NOTICE TO ALL FIRMS

Re: Addendum Number 3
IFB # C1576 – D442 Classroom Renovation

PROJECT:
D442 CLASSROOM RENOVATION
POMERANTZ 300 7TH AVE
NEW YORK NY 10001

SEAL & SIGNATURE:	DATE: 6.7.2023
	PROJECT No: 22520.3
	DRAWING BY: MS/MH
	CHK BY: DH & CK
	DWG No:
	A-300.00
SCALE: AS NOTED	6 of 12

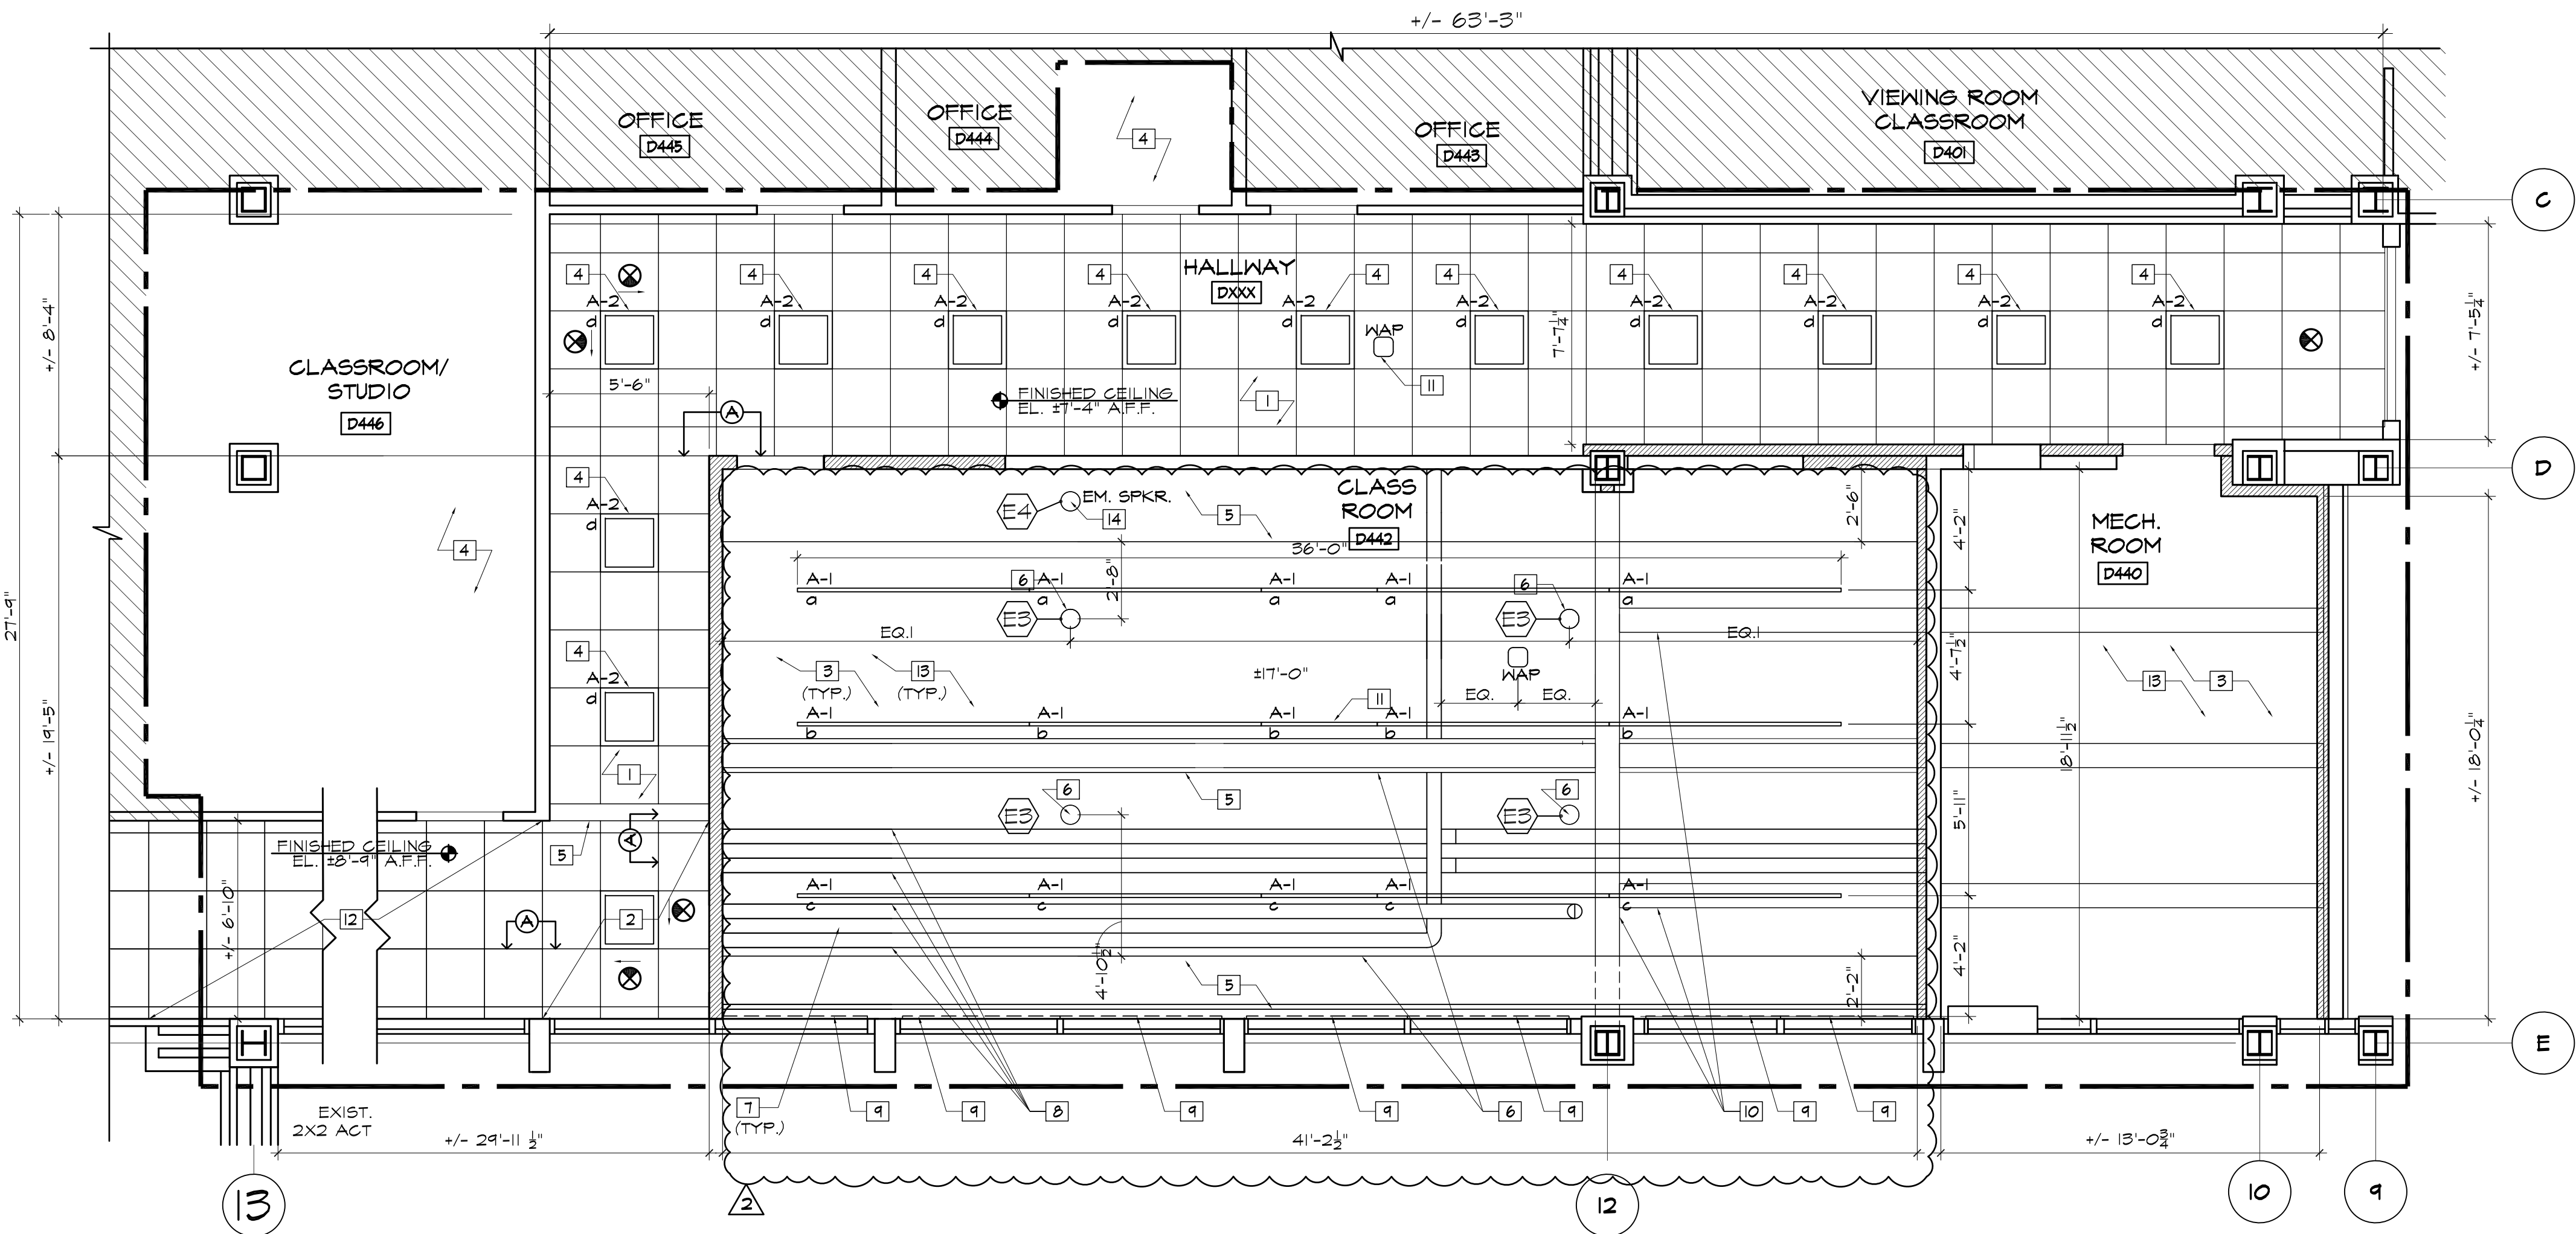
- 1) The due date for the subject bid has been changed from 7/7/2023, 12:00PM to 7/11/2023, 12:00 PM. The RFQ must be emailed to purchasingbids@fitnyc.edu on or before 7/11/2023, 12:00 PM.
- 2) Please find the two revised drawings A-300.00 and A-400.01 (attached below), indicating the changes to the RCP and the elevation.
